**RESOLUTION SCHEDULING PUBLIC HEARING ON APPEAL BY
EYCHANER PROPERTIES, INC. OF THE DENIAL OF A SITE PLAN
AMENDMENT FOR A PROPOSED VALET DROP-OFF LANE AT
322 SOUTHWEST 3RD STREET**

Communication from the City Plan and Zoning Commission advising that at their meeting held October 16, 2014, the following action was taken regarding a request from Eychaner Properties, Inc. (owner) represented by Rich Eychaner for an appeal of an administratively reviewed Site Plan which has been denied based on the design guidelines within the "D-O" Downtown Overlay District on property located at 322 Southwest 3rd Street.

ERG Engineering Research Group, Inc. Engineers and Surveyors 3415 CHASE AVENUE DES MOINES, IOWA 50319 (515) 281-4100		300 MLK VALET DRIVE		NO. _____ REVISION _____ DATE _____ BY _____ FOR _____		LOCATION _____ SCALE: 1" = 20' DESIGNED BY: DJS CHECKED BY: _____ DATE: 9/23/2014 FIELD BOOK: _____ SHEET: 1 OF 1 FILE NO.: 14-090	
--------------------------------------------------------------------------------------------------------------------------------------------	--	----------------------------	--	--------------------------------------------------------------	--	------------------

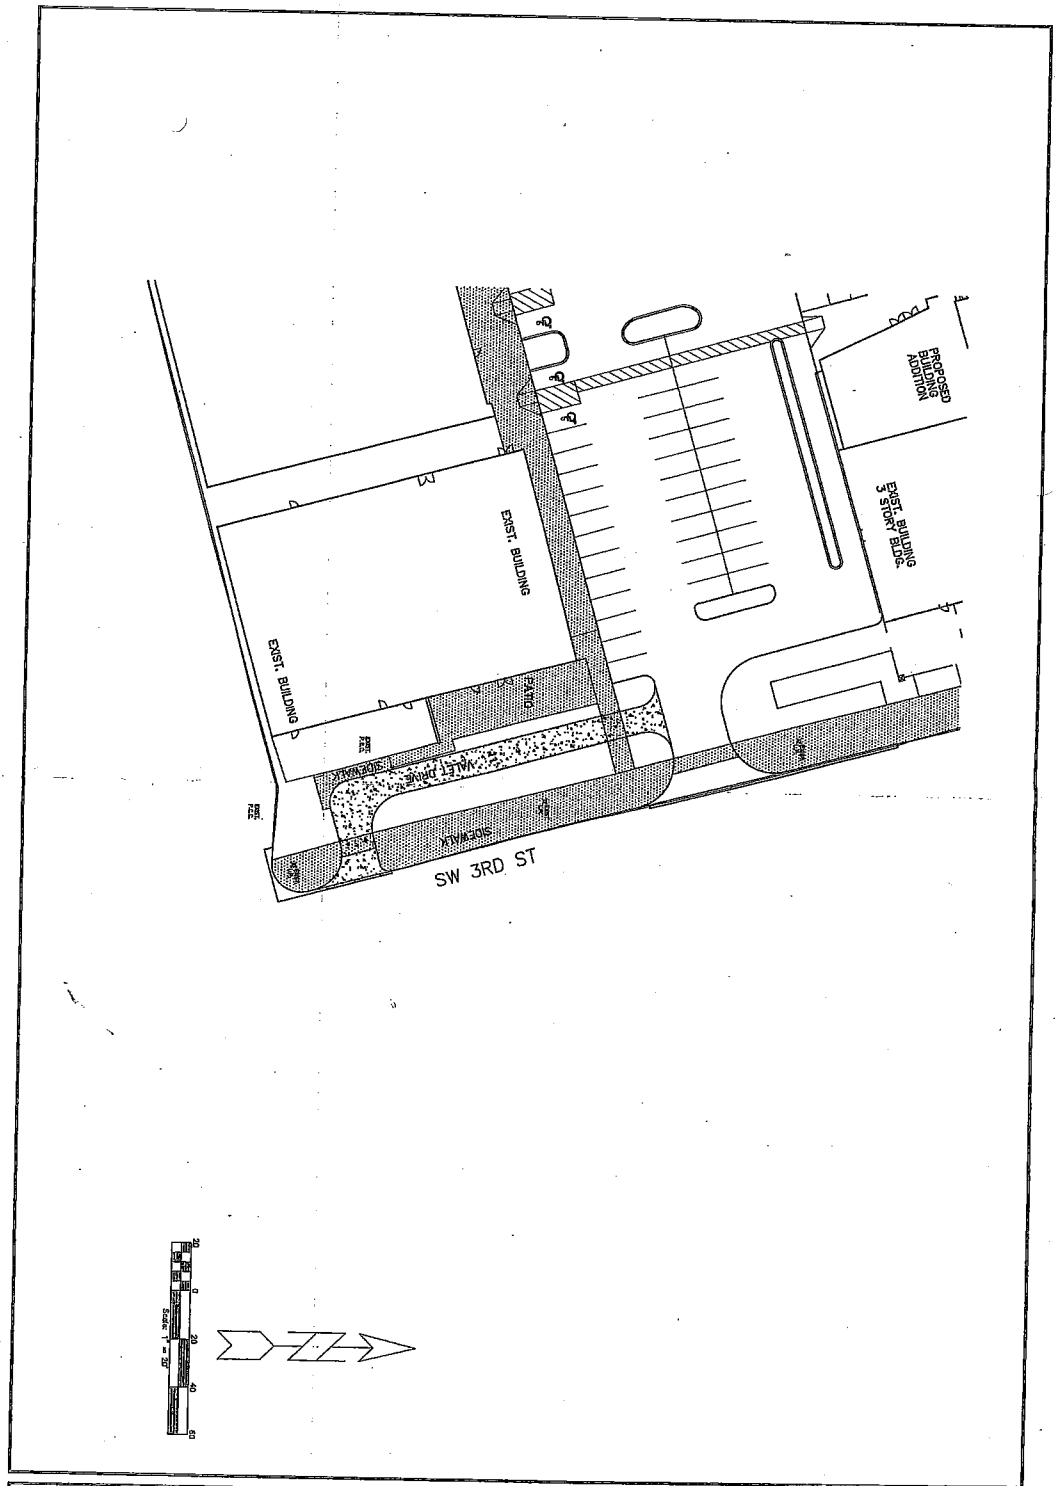
Staff recommends denial of the appeal to allow the proposed drop-off lane along SW 3rd Street.

The addition of the proposed drop-off lane is contrary to the purpose of establishing pedestrian oriented routes within the downtown. The impact of adding the proposed drop-off lane must be viewed in context with the other auto-oriented features that staff has already approved including a drive-thru lane, substantial parking lot frontage along West Martin Luther King, Jr. Parkway and curb cuts on Designated Pedestrian Corridors. A reasonable alternative is to develop a

The "What's Next Downtown Plan" envisions a dense and pedestrian friendly downtown. The proposed drop-off lane does not comply with this criterion as SW 3rd Street is a designated pedestrian corridor and auto-oriented improvements are strongly discouraged.

The buildings are setback from SW 3rd Street. The applicant is proposing patio and plantings in this area. The proposed drop-off lane would reduce the amount of onsite green space.

Staff does not support the addition of the proposed drop-off lane as it is contrary to the purpose of establishing pedestrian oriented routes within the downtown. The impact of adding the proposed drop off lane must be viewed in context with the other auto-oriented features that staff has already approved. A reasonable alternative is to develop a valet drop-off area within the parking lot to the north of the subject building. The additional parking spaces that were added to the Site Plan by allowing the trash enclosure to be developed offsite would offset the potential loss of parking. Tenant turnover could greatly alter the scope and magnitude of the lane's use in the future. A designated drop-off lane within the parking lot could be easily converted to parking spaces should tenant change occur.

Staff believes that a single curb cut to West Martin Luther King, Jr. Parkway and a single cut to SW 3rd Street are the minimum number necessary to support the development. The proposed drop-off lane would add a second curb cut to SW 3rd Street.

DENIAL of the request for a valet drop-off lane along SW 3rd Street. (10-2015-7.40)

Dann Flaherty moved staff recommendation Deny the request for a valet drop-off lane along SW 3rd Street.
